MMO Reference: DCO/2022/00001  
Planning Inspectorate Reference: EN010121  
Identification Number: 20049449

## **Planning Act 2008, Floatation Energy, Proposed Morecambe Offshore Windfarm Generation Assets**

### **Deadline 5 Submission**

Figure 1 Location of disposal sites in relation to Projects

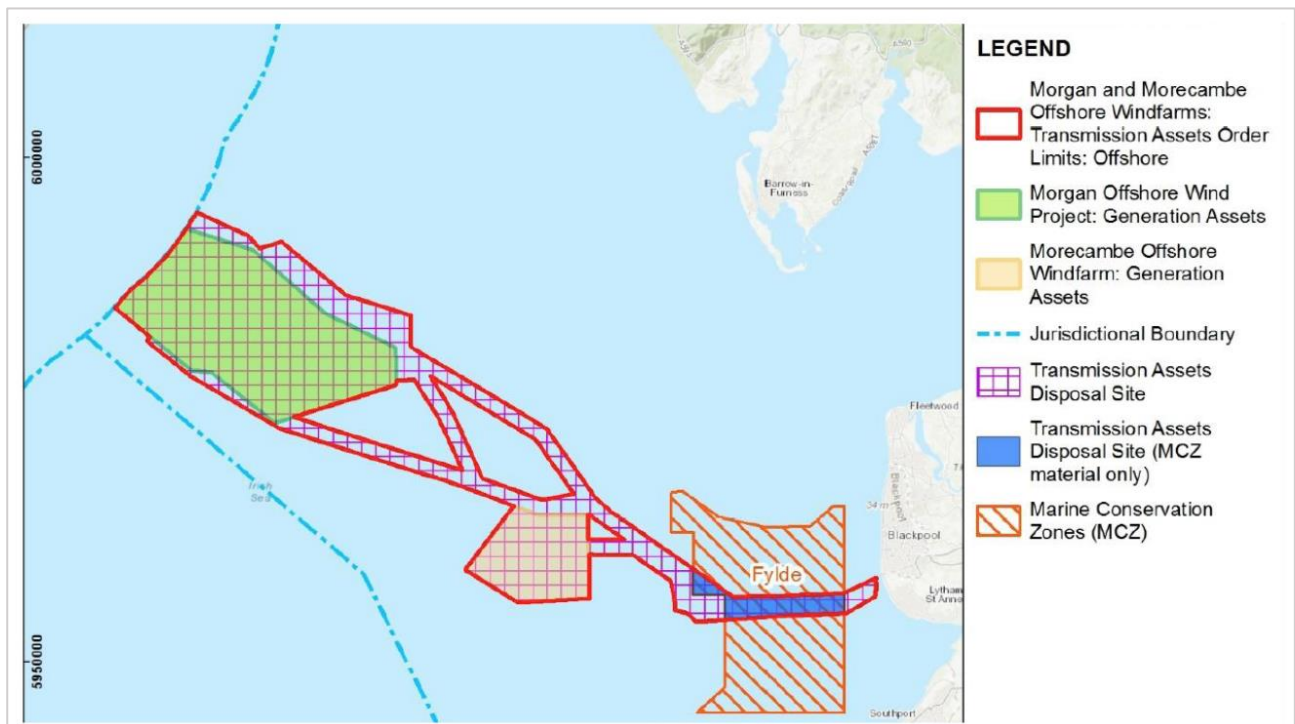
R17.1.3	MMO	<p><b>Disposal site(s)</b></p> <p>The MMO response to the Applicant's response RR-047-47 says that the MMO is "currently working to designate disposal sites and will provide further comments in due course". A full update should be provided at D4, including the extent of any proposed designated sites.</p>	<p>The MMO and the Applicant had a meeting on 14 February, the MMO received a shape file of the red line boundary (assessed disposal site area) after this meeting and is reviewing all information and working with our scientific advisors to designate the disposal site. The MMO is aiming to receive confirmation early March and will provide the reference number to the Applicant to be updated in the disposal conditions on the DML for Deadline 5.</p> <p><b>Deadline 5 update</b></p> <p>The Applicant submitted shapefiles for the designation of the disposal site to the MMO.</p> <p>The MMO would like to note that this disposal site has been designated, and the reference number should be updated within the DML as per Section 7, the reference number is IS156 and the name of the site is the Morgan and Morecambe OWFs (Annex 1, Figure 1).</p> <p>The reason this is a joint designation is the transmission assets disposal site that has also been requested as part of the Morgan and Morecambe Offshore Windfarm Transmission Assets disposal site overlaps with the Morecambe generation asset site. Therefore, these have been included together along with the transmission asset areas because disposal sites cannot overlap.</p> <p>As all the disposal material has been assessed including cumulative impacts there is no concern with multiple projects utilising the same disposal site as long as their disposal quantities are within the maximum parameters assessed.</p>
